CITY OF ALBUQUERQUE

PLANNING DEPARTMENT – Development Review Services

July 8, 2016

**RE: Calvary Church – Gym Building
Grading & Drainage Plan/Report
Engineer's Stamp Date 5-31-2016 (File: J22D027A)**

GRADING PLAN

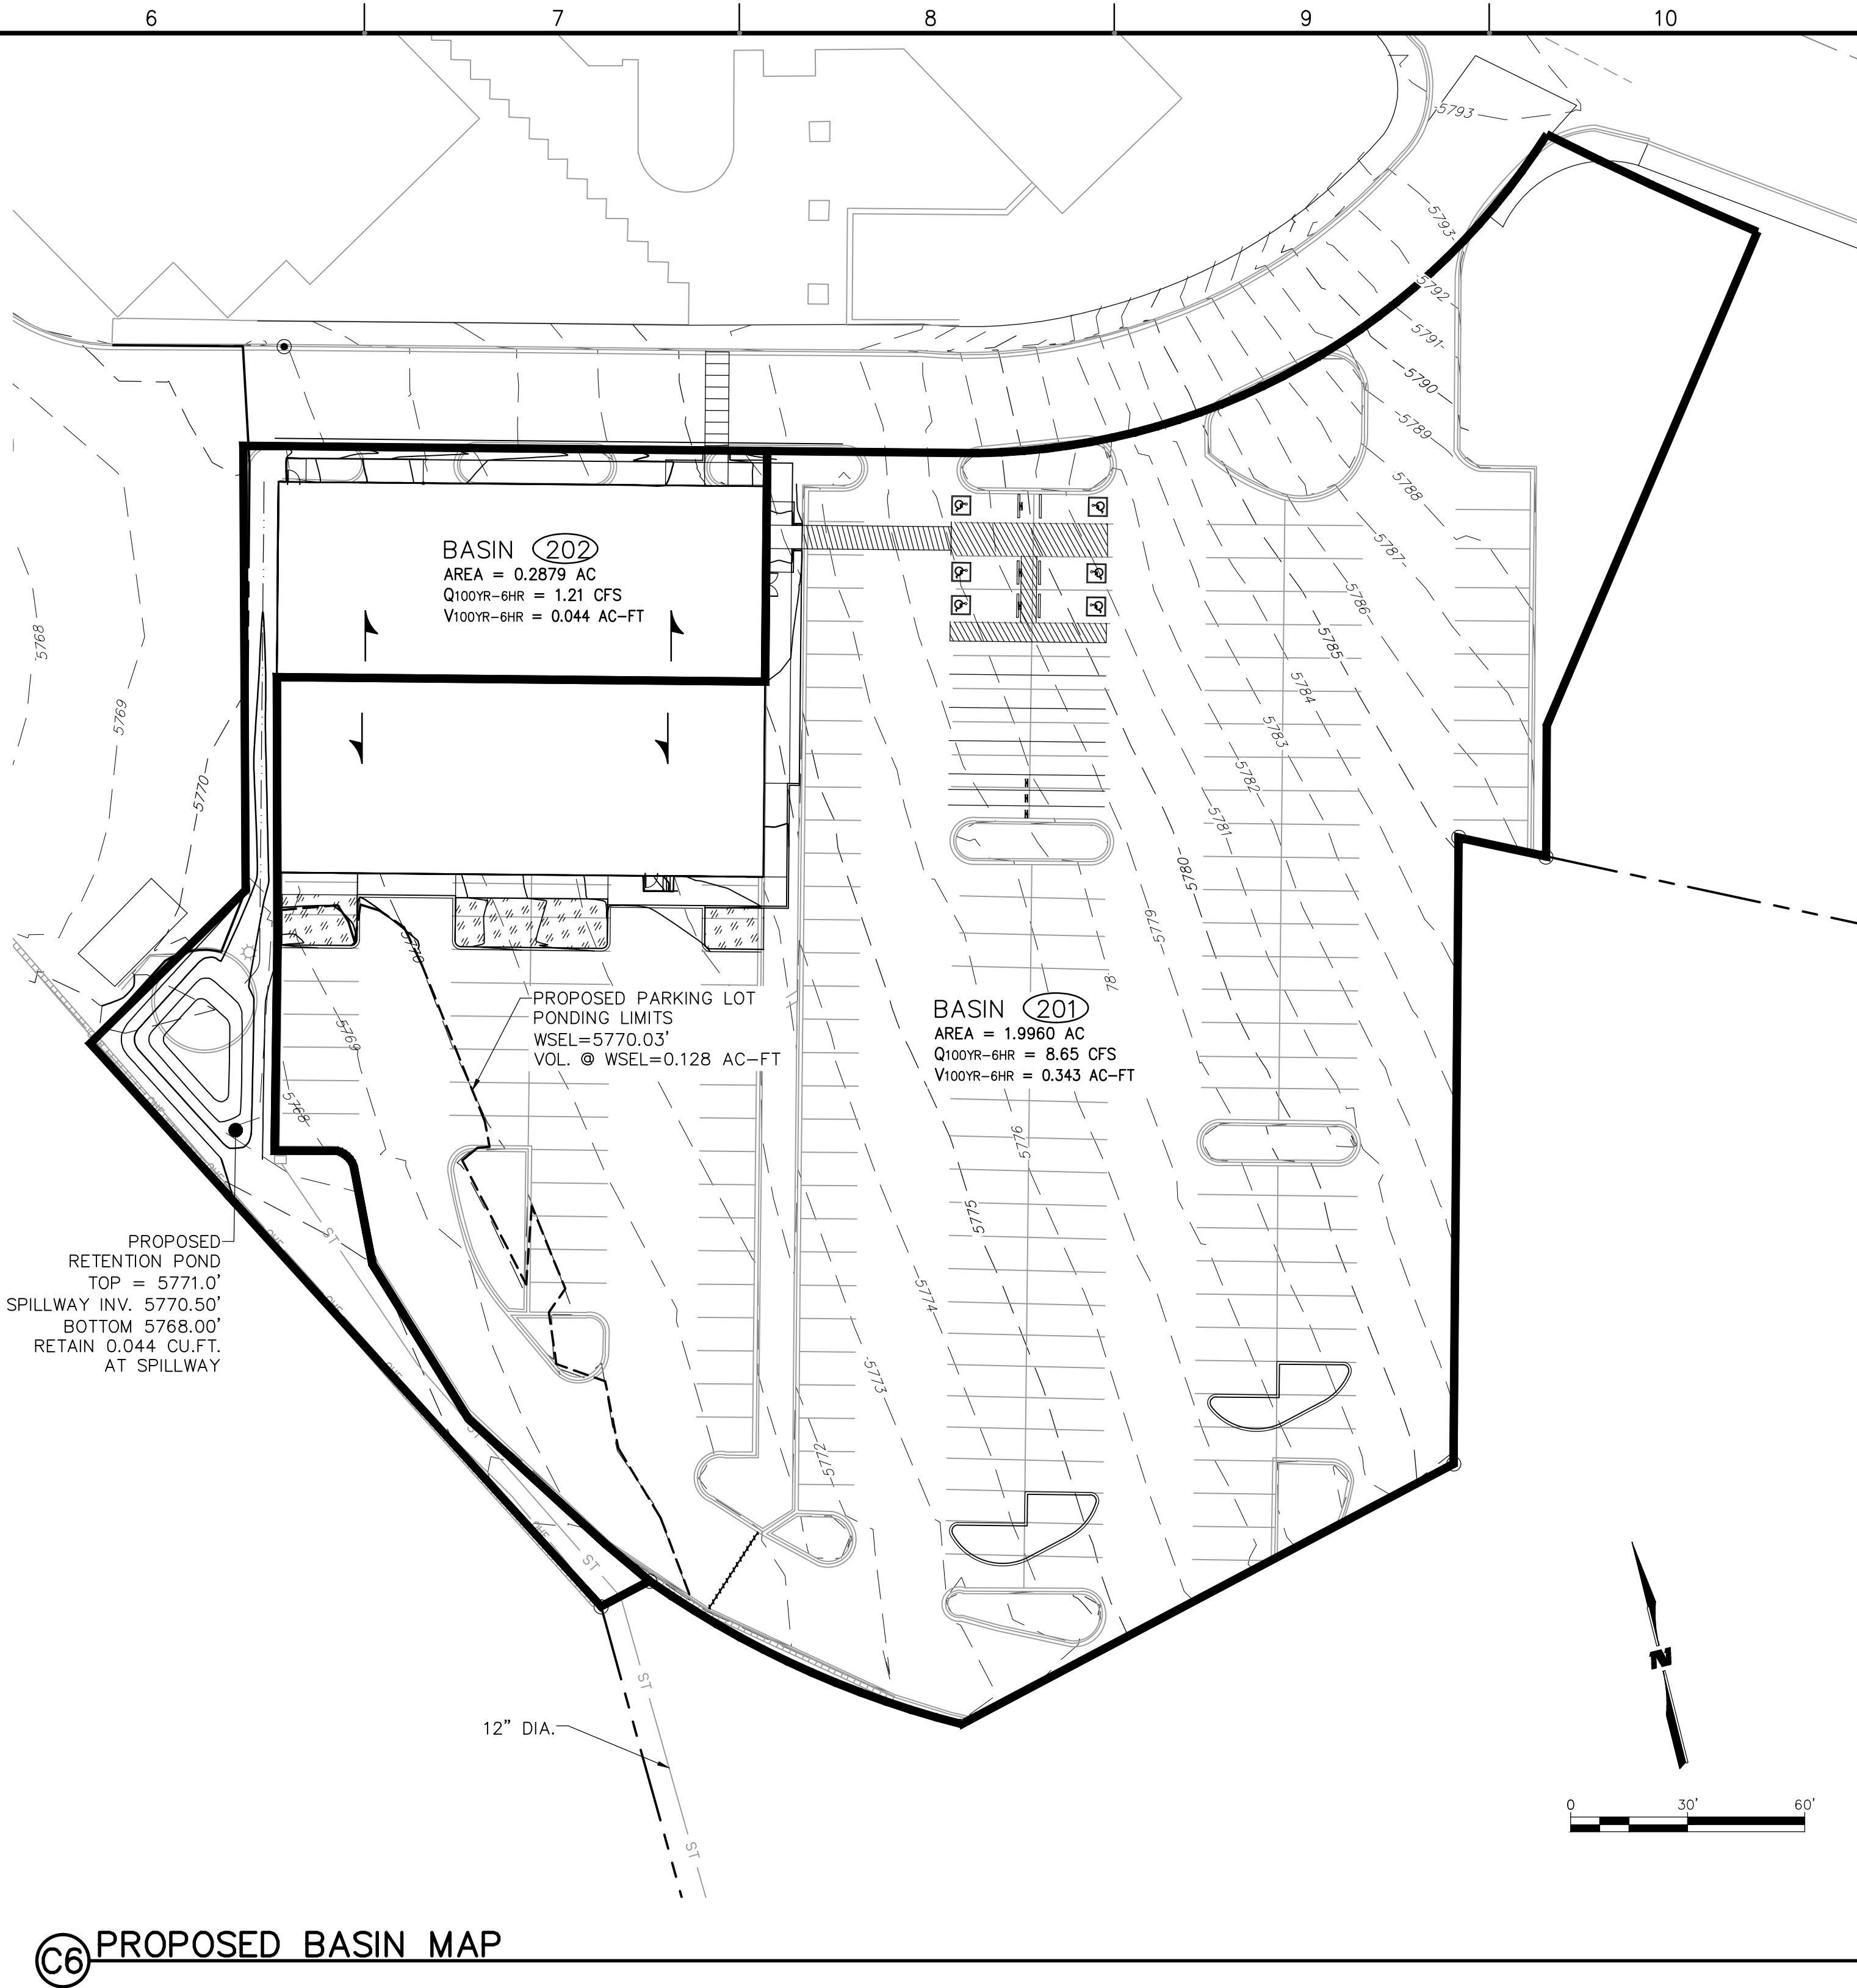
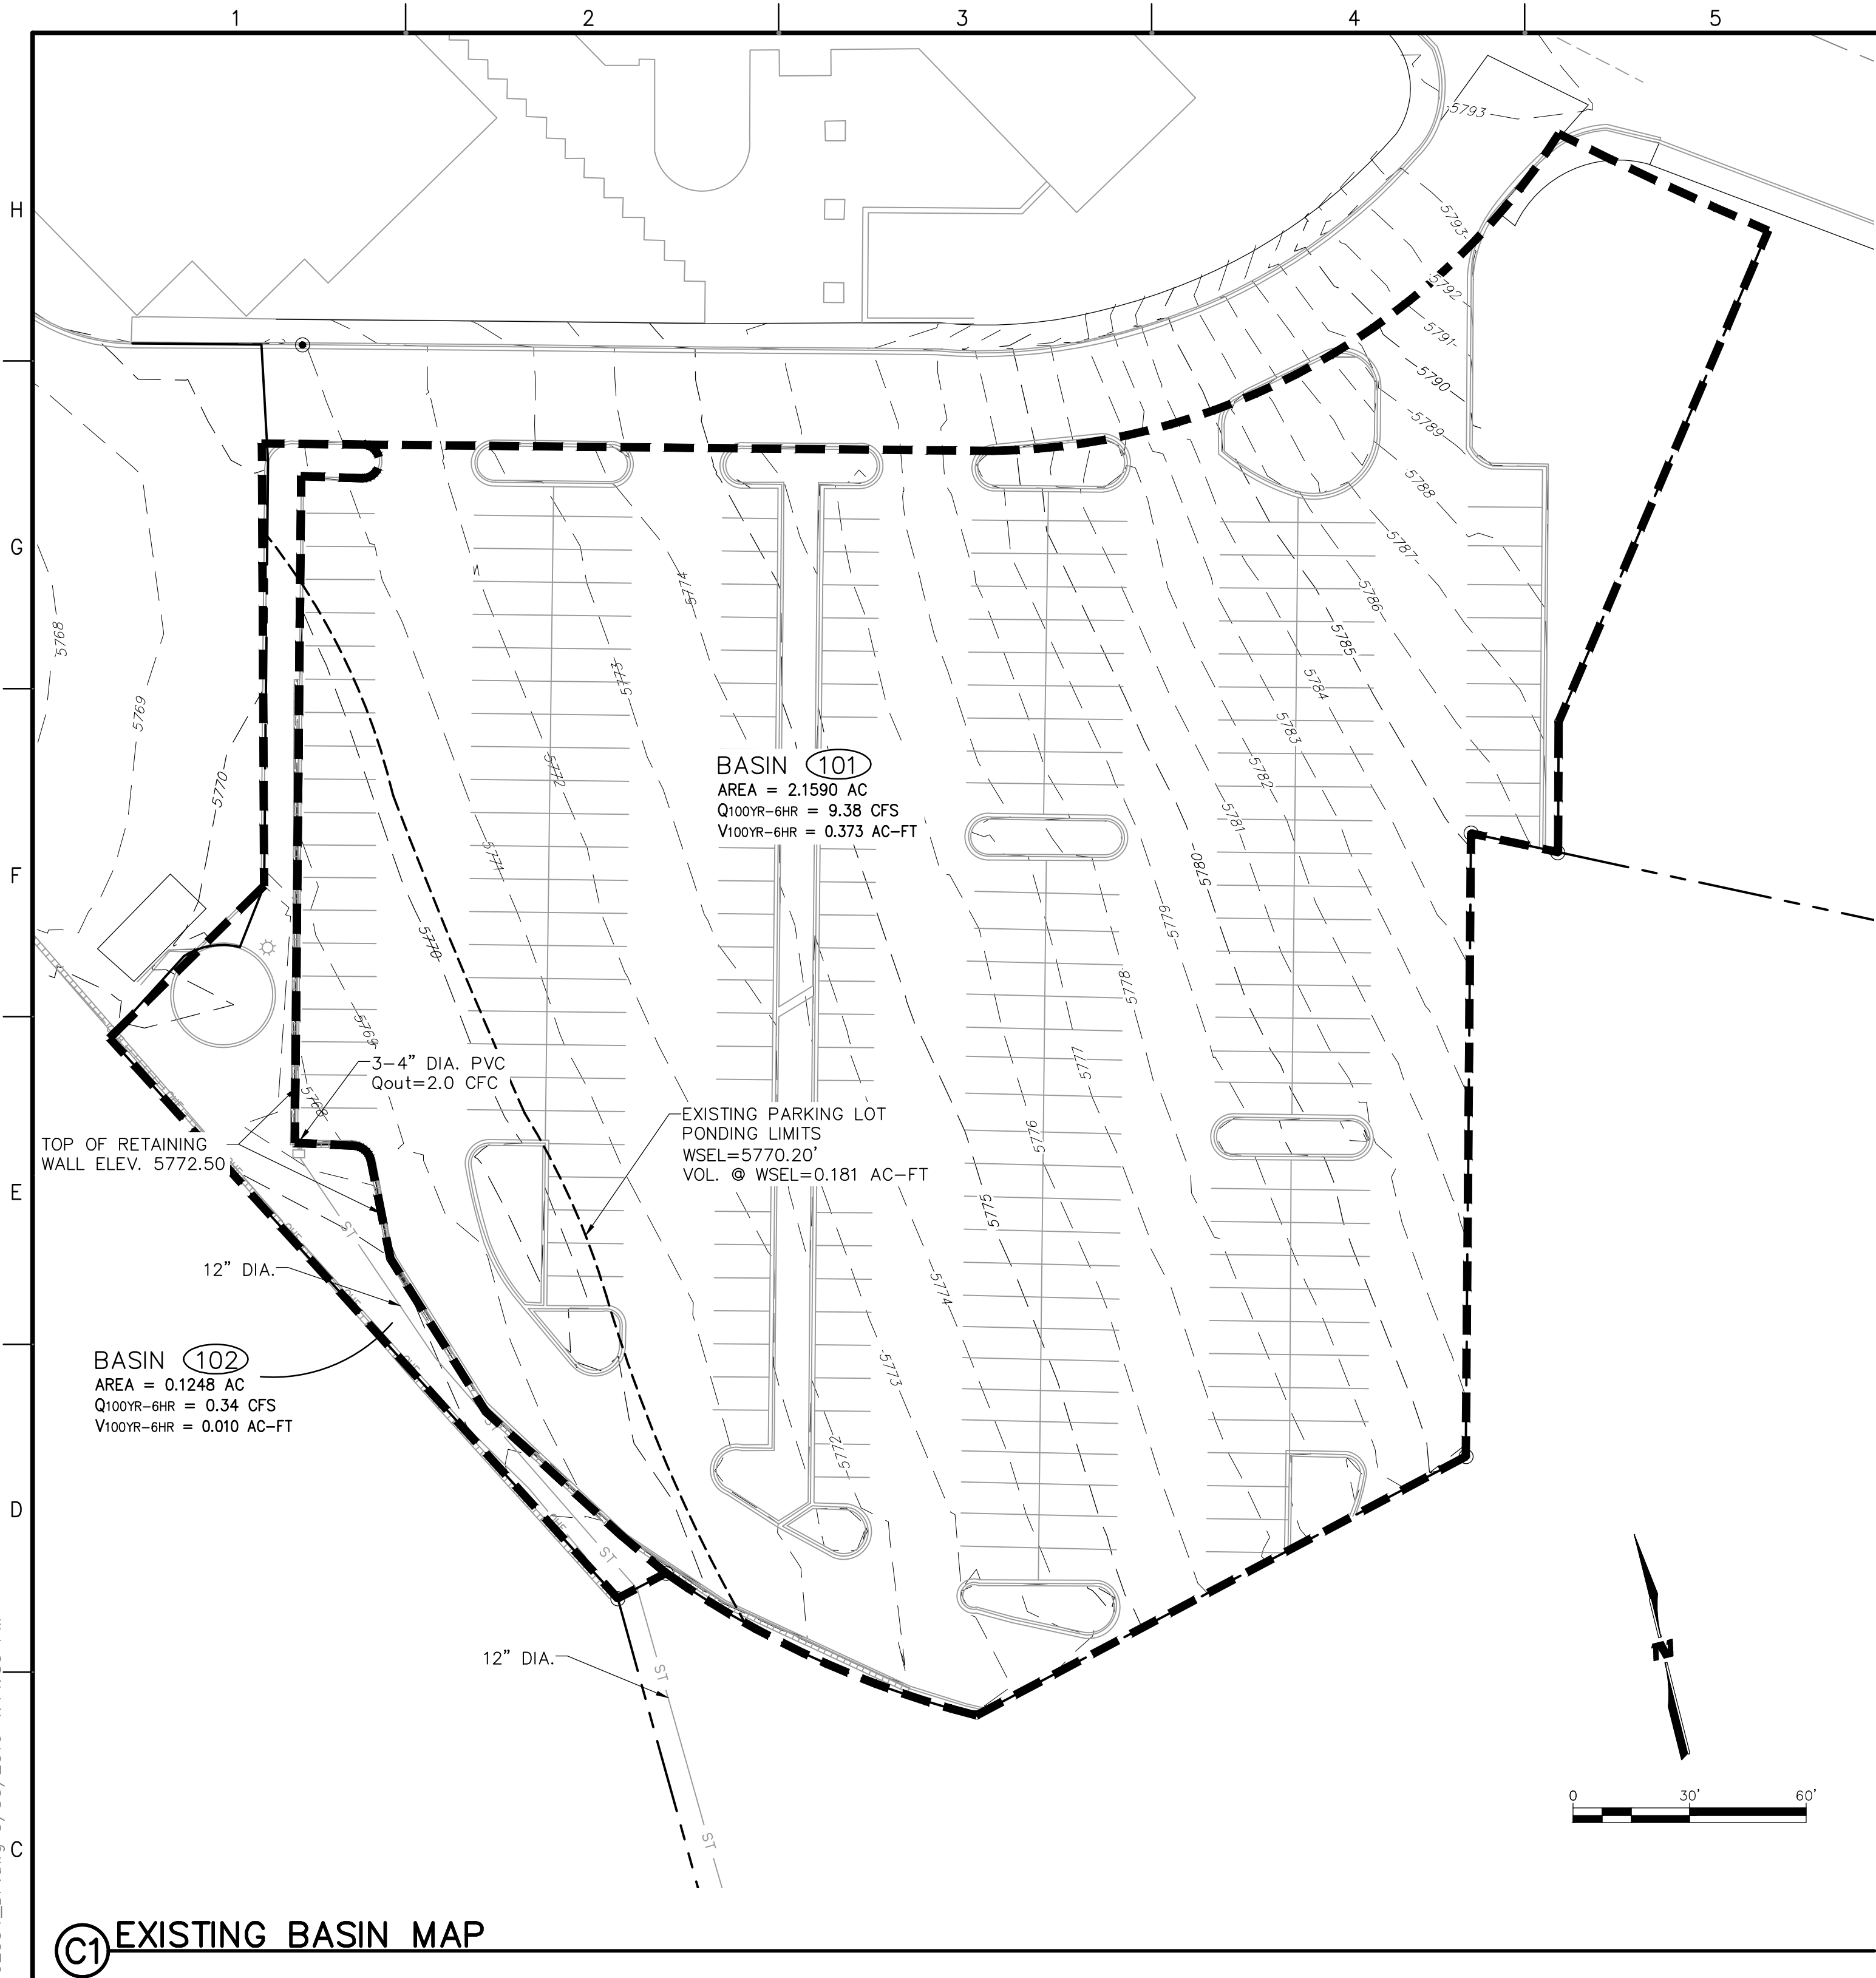
- The roof drains will not be allowed to discharge onto the sidewalk surface, flows need to be routed under the sidewalk with a culvert or piping. These improvements will need to be shown on the certification.
